DESIGN REVIEW RECOMMENDATION

SDCI # 3035216-LU
4007 - 4015 Stone Way North
Seattle, WA 98103

Applicant:
Cone Architecture, LLC
1319 N 49th Street
Seattle, WA 98103
Contact: Summer McEneny

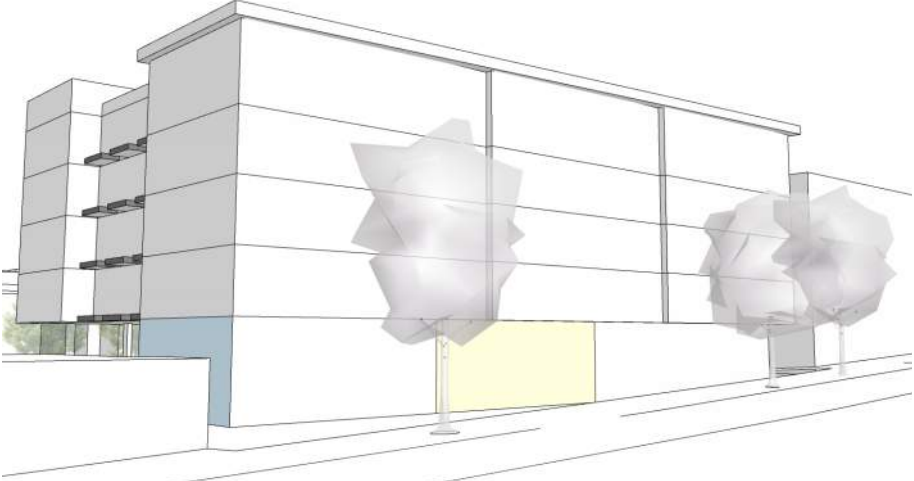
The Board supported the preferred massing option (option 3) as the basis for further refinement but asks for a further development of the angled bays along Stone Way. The bays could be angled to better take advantage of the views to the south from Stone Way.

Thank you for supporting our preferred option. As a result of a future commercial tenant's needs, we have mirrored the positioning of the massing on the site. This will impact all comments from here on forward and will be addressed accordingly.

The angles of the south mass have been revisited to create a new form that will provide more modulation between the base and the top of the building. The residential entry now exists on the north portion of the overall building, highlighted by the wood screen element that signifies its location . The north mass anchors the building to the site while the angled mass to the south provides visual interest and provides more uninterrupted views to the south.

EDG MASSING SOUTHEAST

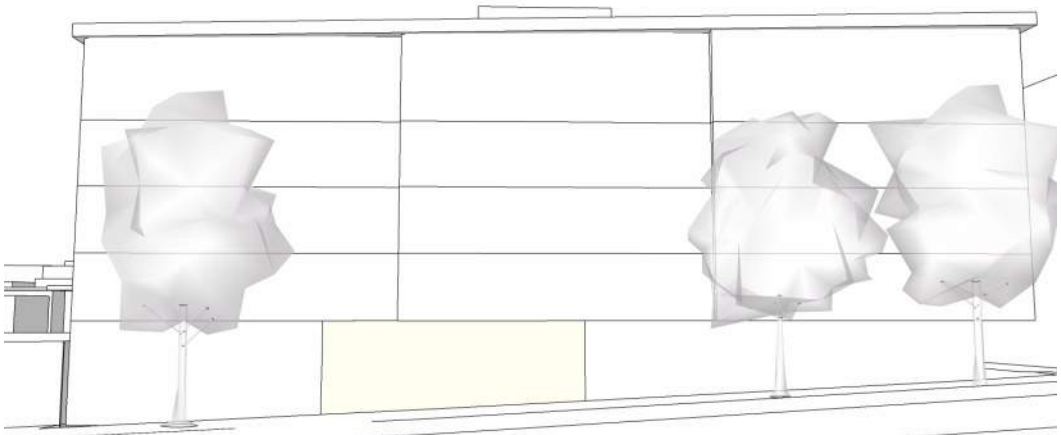
The shallow slope of the roof lacks legibility and the continuous form appears monotonous. Accentuate the slope of the roof and continue the offset between the angled bays to the top of the massing, breaking the roof form.

We have acknowledged your feedback and implemented a roof form that is more dynamic than a simple shed roof that runs the entire length of the building. We have removed the shed roof and instead have implemented angles along the parapet walls themselves. This allows for the angle in plan to be carry to the top of the form as requested as well as providing an angle in elevation to define a strong roofline against the sky.

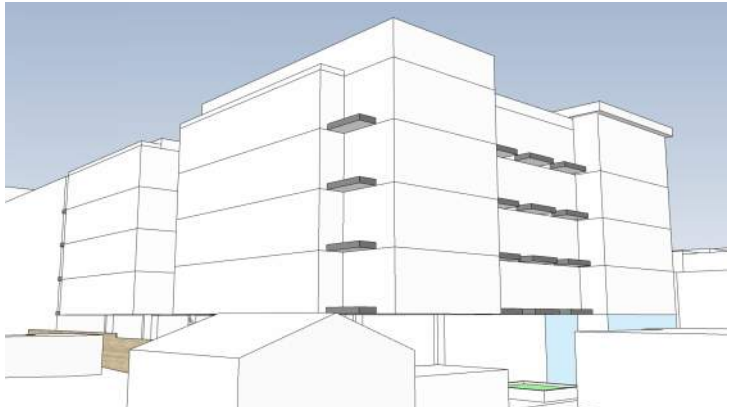
Staff is also concerned with the height, bulk and scale impacts at the rear setback of the zone transition. Modify the proposed massing to respect the required setback while maintaining a massing break with helps break down the scale.

The building has been adjusted to respect the LR zone setback while retaining a massing break to the west. In addition, a portion of the building adjacent to the massing break at level 5 has been removed to reduce height, bulk, and scale and provide more light for the single family homes to the west.

PRIVACY STUDY OF WEST FACADE / LR1 ZONING

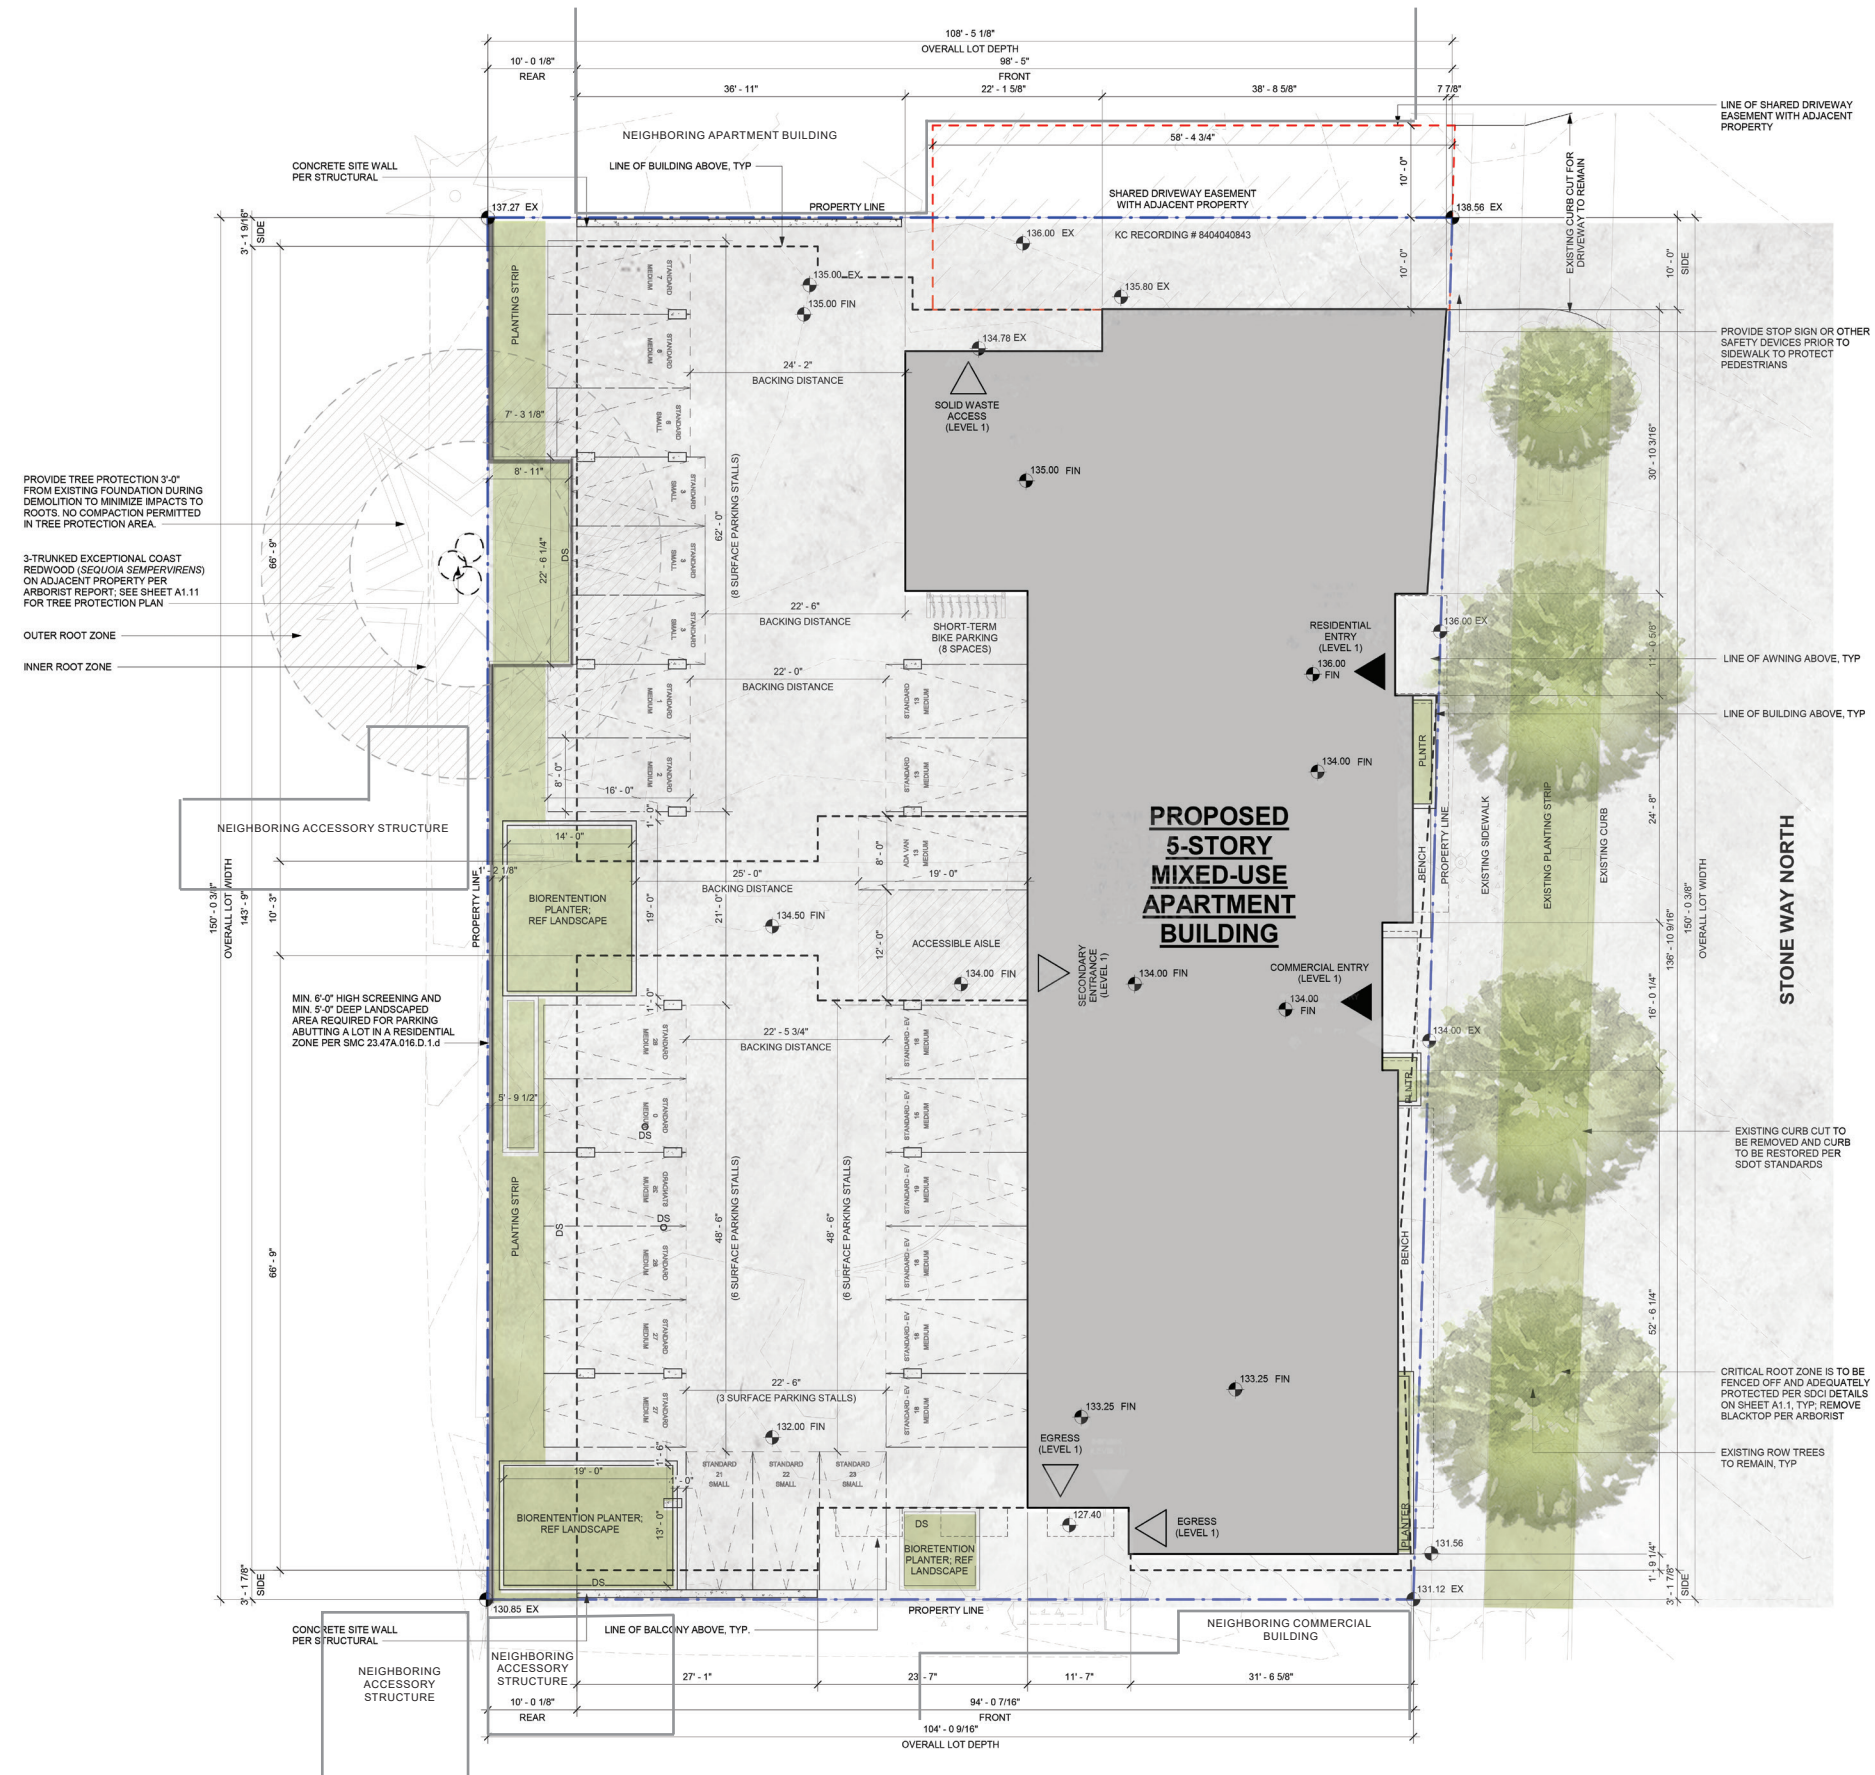
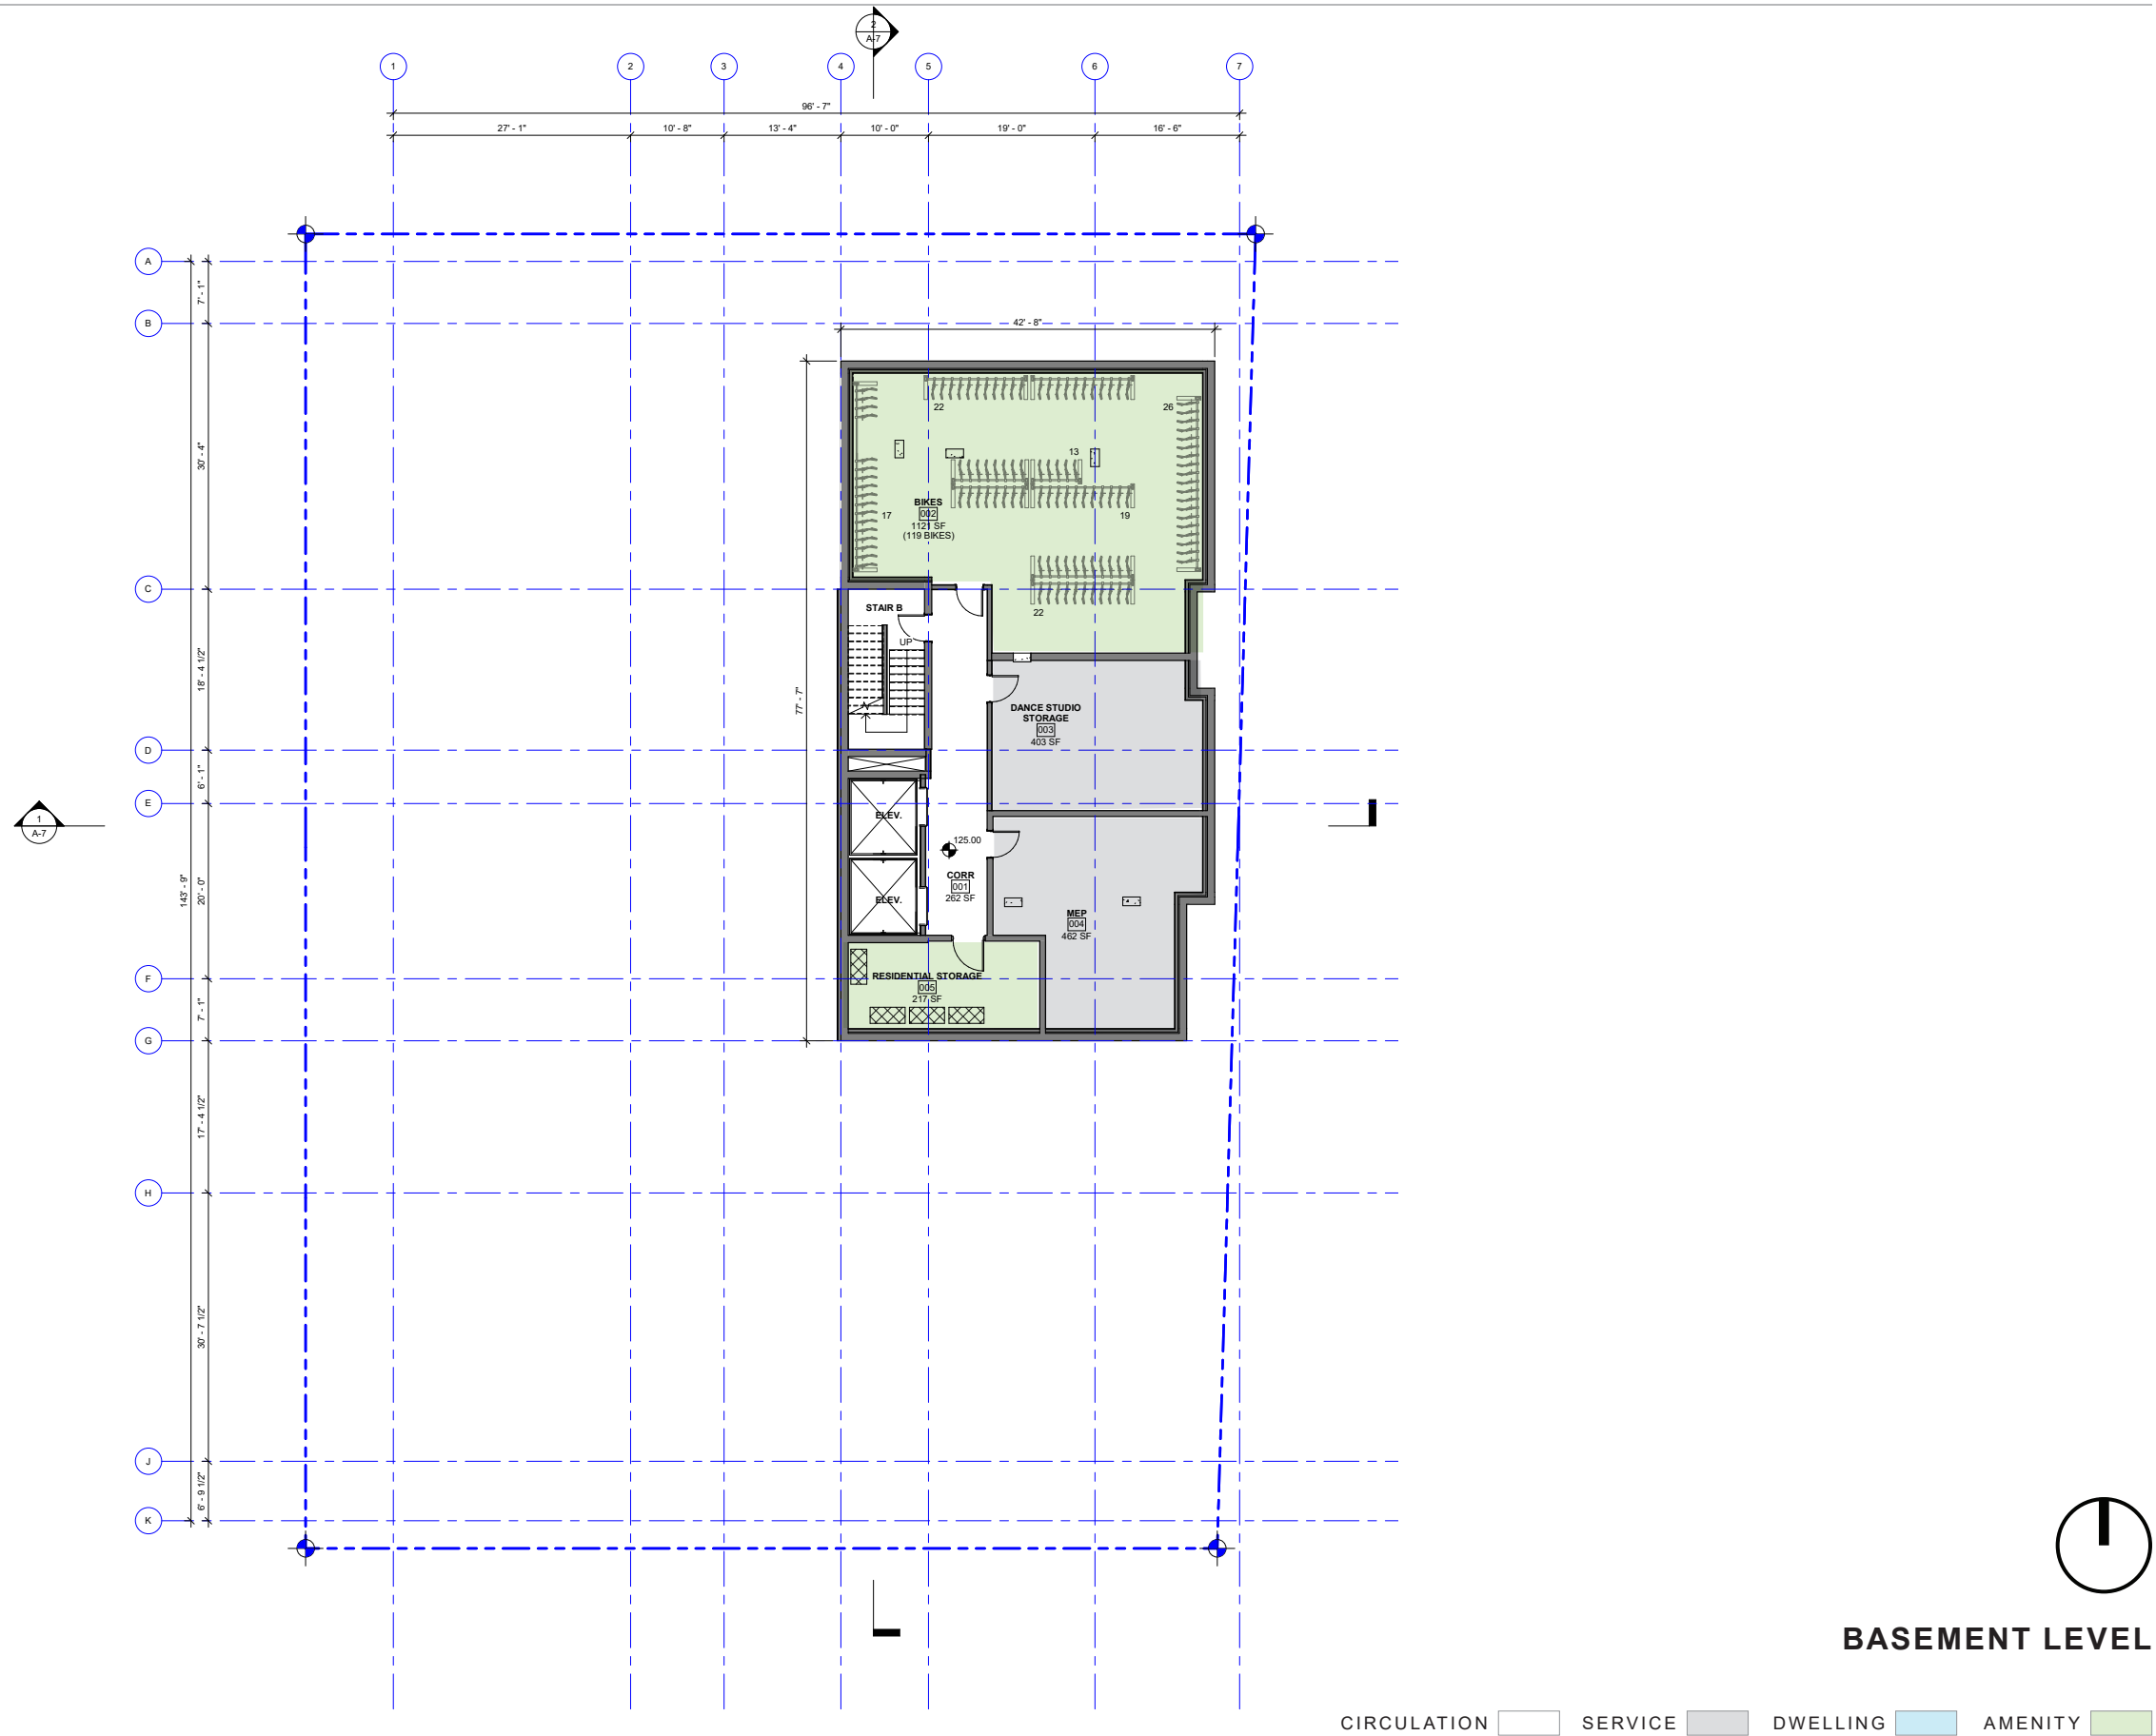
The board requested a careful studies of the privacy considerations for single family neighbors to the west.

The height of the west facing volumes has been minimized as much as possible, and the glazing arrangement avoids a lot of windows facing directly west. See provided privacy studies on page 28.
